Permit Number: 051010

RE: Lot #2 Ballpark Drive – 371-A-032 - R-2 Zone – application #05-1010

CHECK-LIST AGAINST ZONING ORDINANCE

ONE AND TWO FAMILY	PLAN REVIEW	CHECKLIST
Soil type/Presumptive Load Value (Table R401.4.1)		
Component	Submitted Plan	Findings/Revisions/Dates
STRUCTURAL		
Footing Dimensions/Depth (Table R403.1 & R403.1(1), (Section R403.1 & R403.1.4.1)	8x16 - 8' OK	
Foundation Drainage, Fabric, Damp proofing (Section R405 & R406)	Not shown	
Ventilation/Access (Section R408.1 & R408.3) Crawls Space ONLY	N/A	
Anchor Bolts/Straps, spacing (Section R403.1.6)	Bolt size -	SPACING FROM CORNERS IS NOT SPEC'ED OUT
Lally Column Type (Section R407)		
Girder & Header Spans (Table R 502.5(2))		
Built-Up Wood Center Girder Dimension/Type	Need design on steel + LVL'S. Pgs #3 + #5	Spec condition
Sill/Band Joist Type & Dimensions	2x6 PT	
First Floor Joist Species Dimensions and Spacing (Table R502.3.1(1) & Table R502.3.1(2))	9 1/2" A JS	Need CORNER design sheets
Second Floor Joist Species Dimensions and Spacing (Table R502.3.1(1) & Table R502.3.1(2))	" "

FOUNDATION PLAN
1/4" = 1'-0"

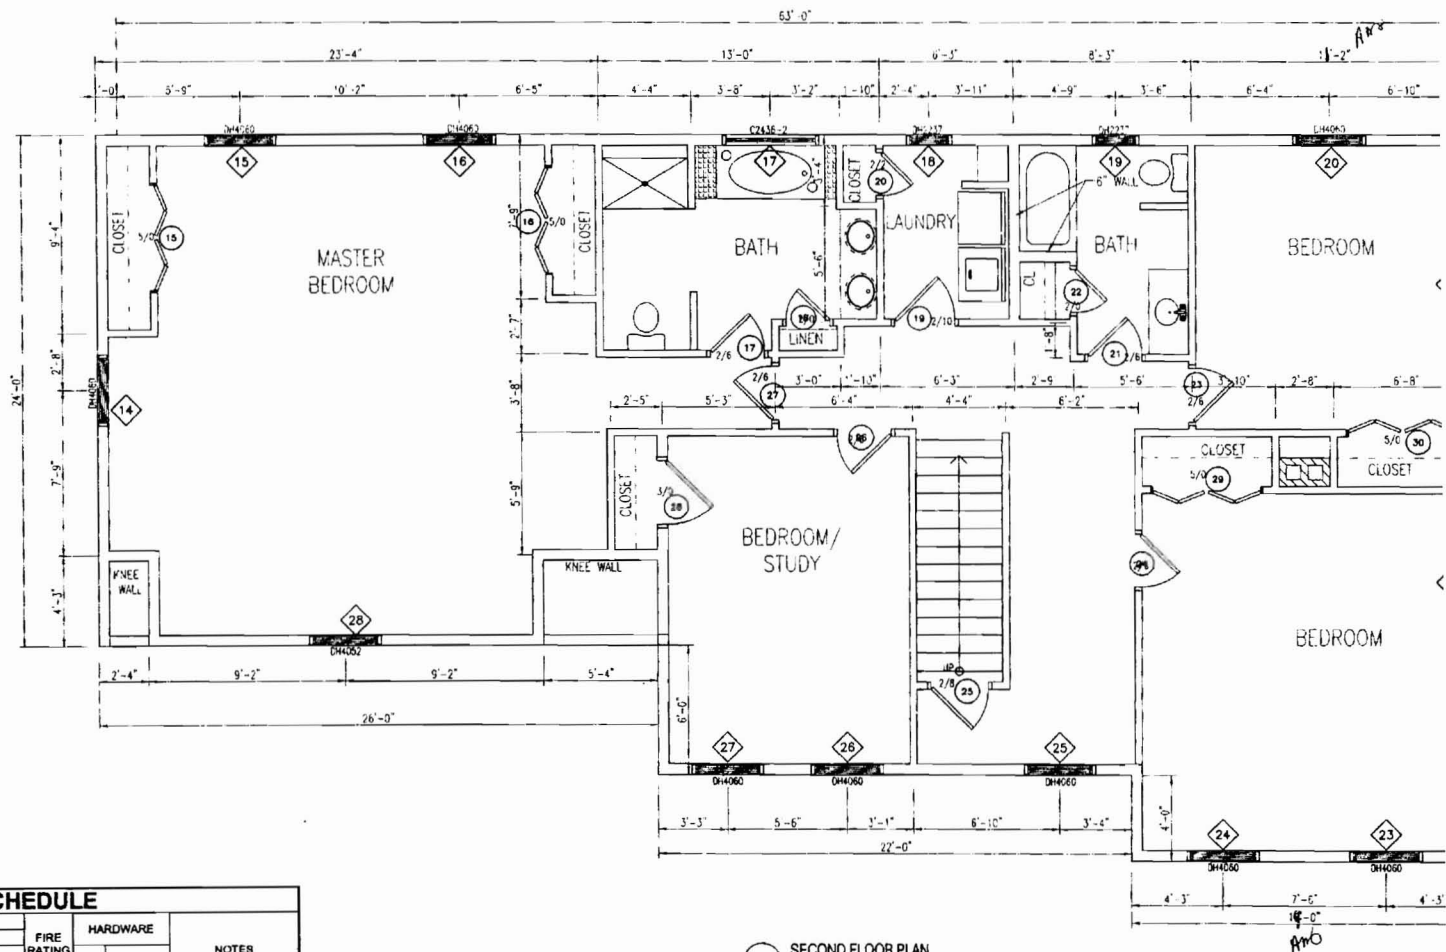
Factor Fenestration		
Type of Heating System	Not shown Off	
Means of Egress (Sec R311 & R312)		
Basement 2 -	Need door to outside if	finished space in bsmnt
Number of Stairways 3		
Interior 2		NO FINISHED SPACE
Exterior 1		
Treads and Risers (Section R311.5.3)	Riser - OK 7 3/4" - 10" Tread	EXCESSIVE, nose to nose 10" OK
Width (Section R311.5.1)	Not shown Page # 3 1/4" wide	Page # 4 (48" wide) OK
Headroom (Section R311.5.2)	- OK	
Guardrails and Handrails (Section R312 & R311.5.6 - R311.5.6.3)	- Not shown	34" rail 3" space
Smoke Detectors (Section R313)	Not shown	Smokes per code 10/5/05
Location and type/Interconnected		
Dwelling Unit Separation (Section R317) and IBC - 2003 (Section 1207)	N/A	
Deck Construction (Section R502.2.1)	Need better detail	10x16 2x8 16" O.C. OK

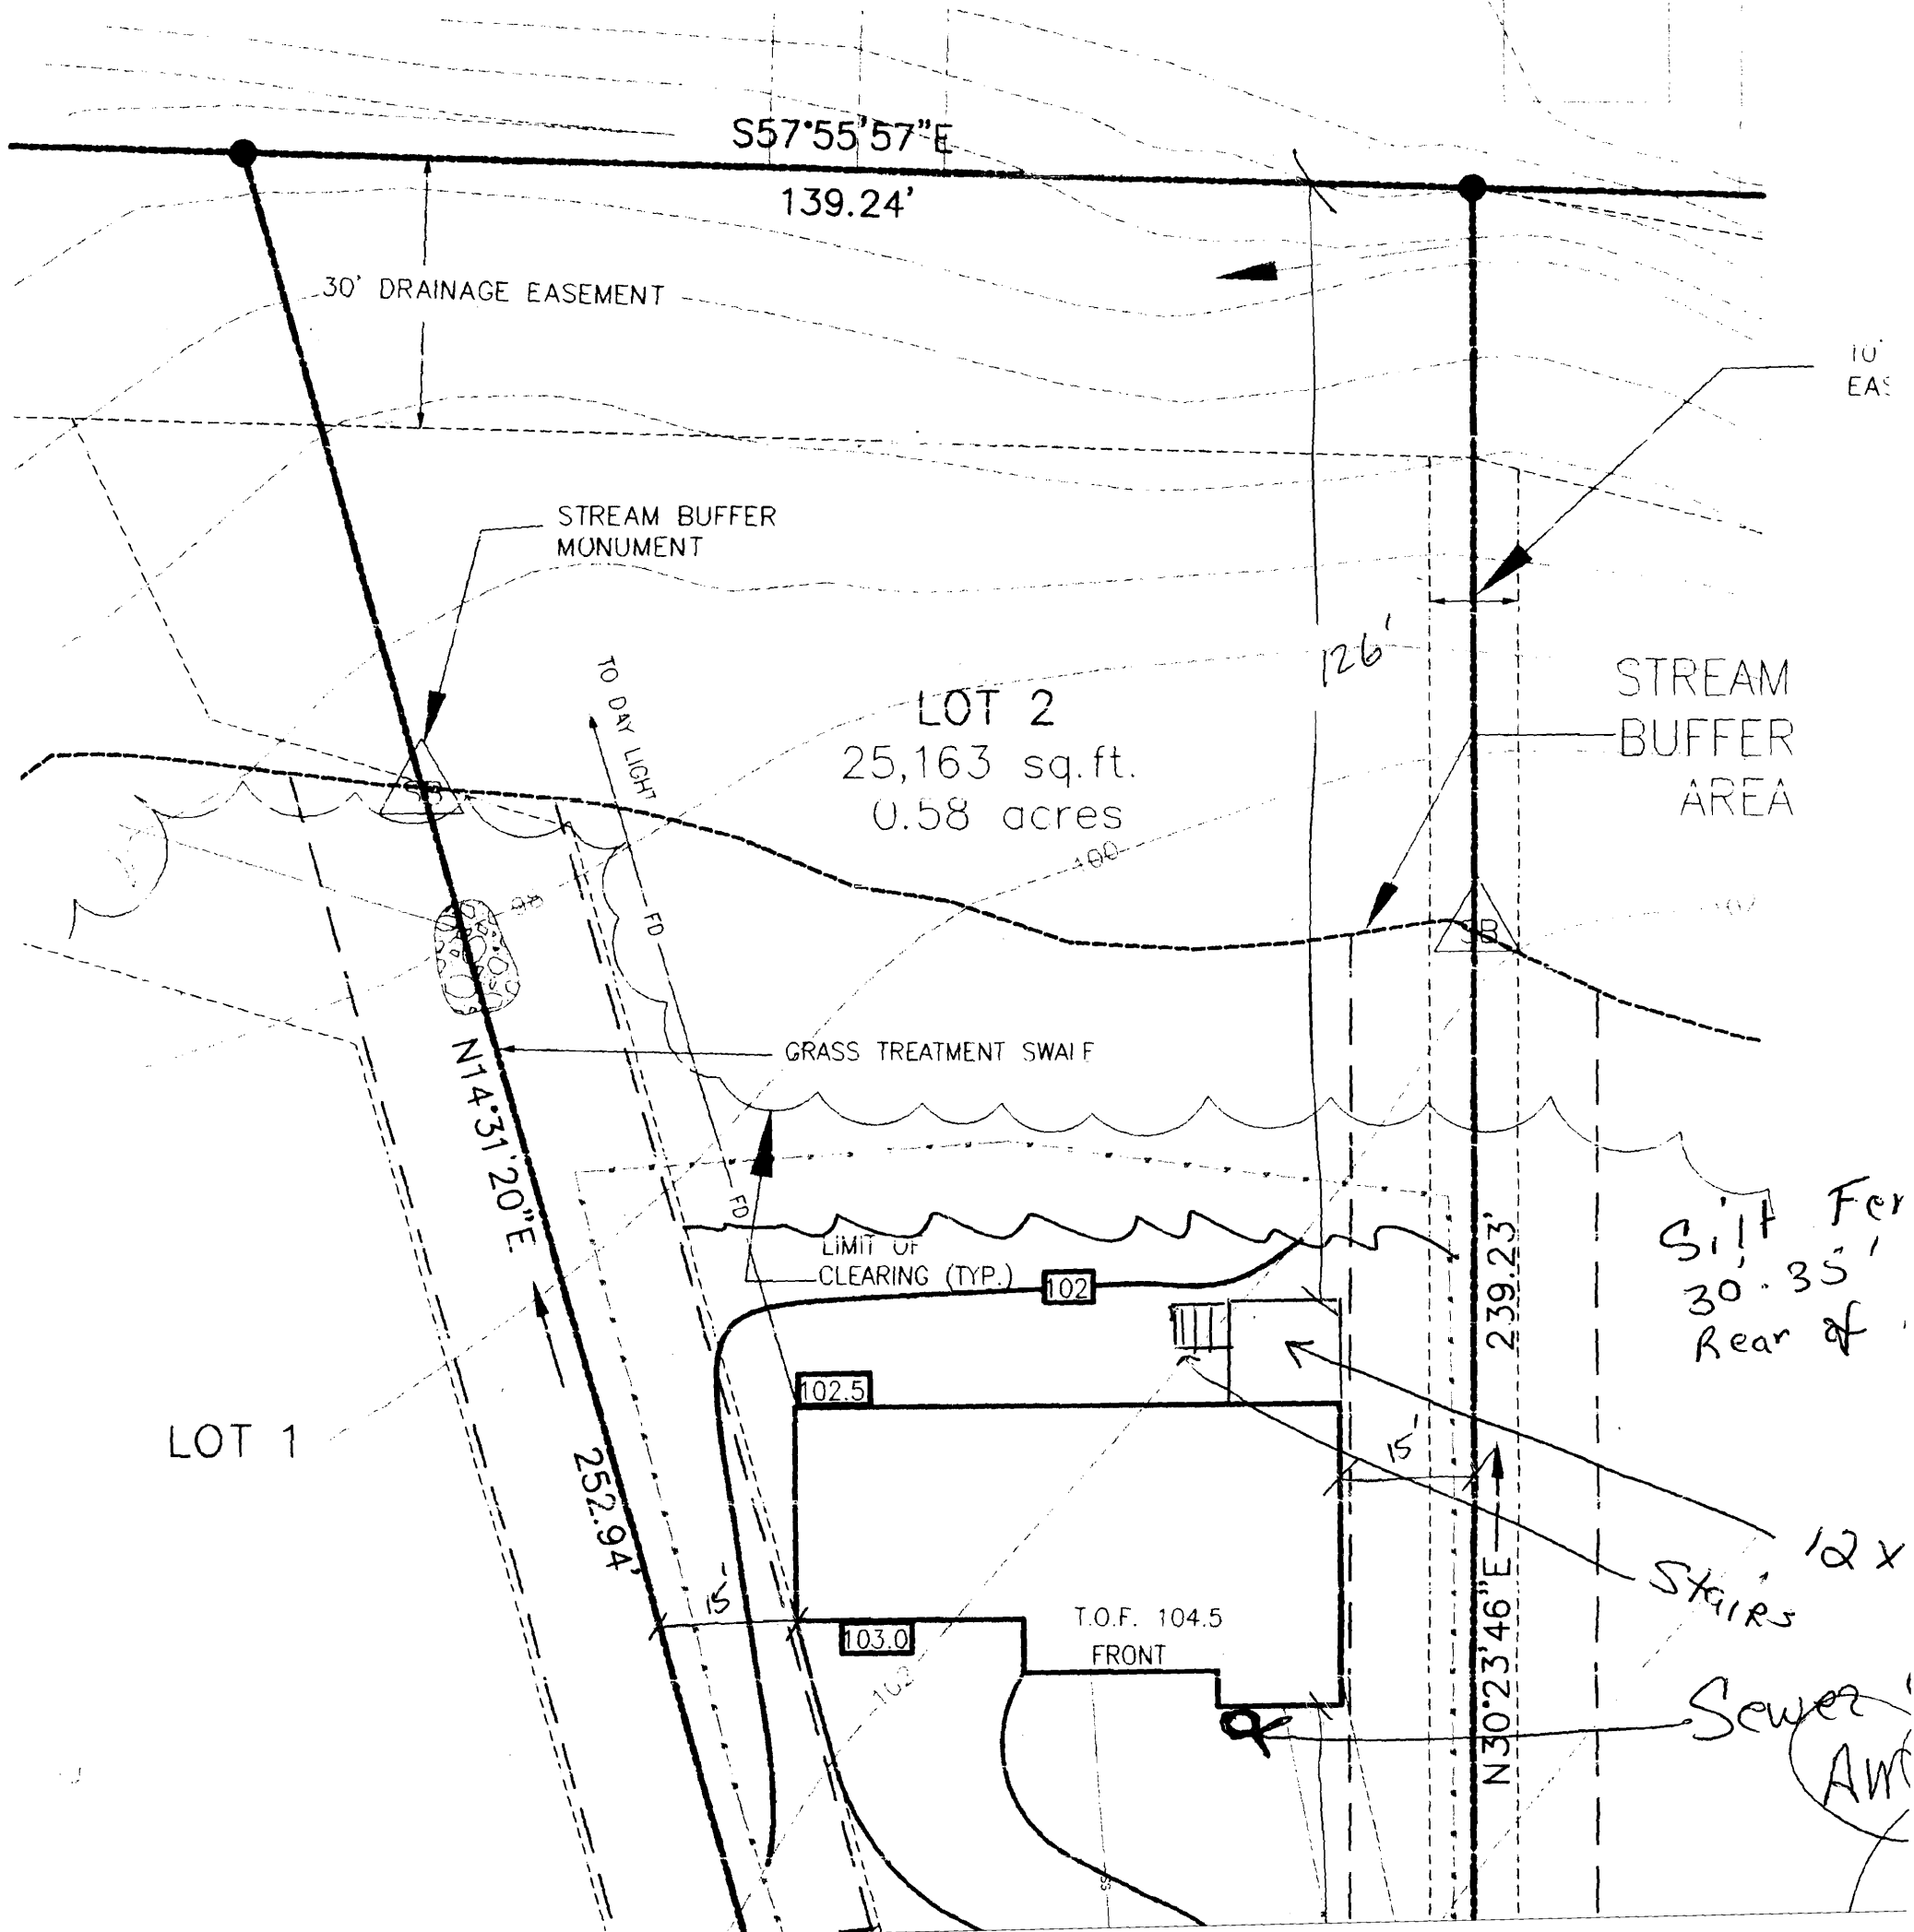
2 story
Projections - ? 12 x 12 & stairs 5' x 7' -

NO BAY WINDOW

Need Scaled plans & needs to match the
Bldg plans
received 8/15/05

Note: 8/9/05 Do not have a scaleable site plot plan and what I have does not show all projections like a rear deck and side bay window - see letter - on hold in M's hold area **Ok to Issue:**
8/15/05 - at 4:00 pm brought in scaled drawings and revised the plans to show the rear deck and removed the side bay window
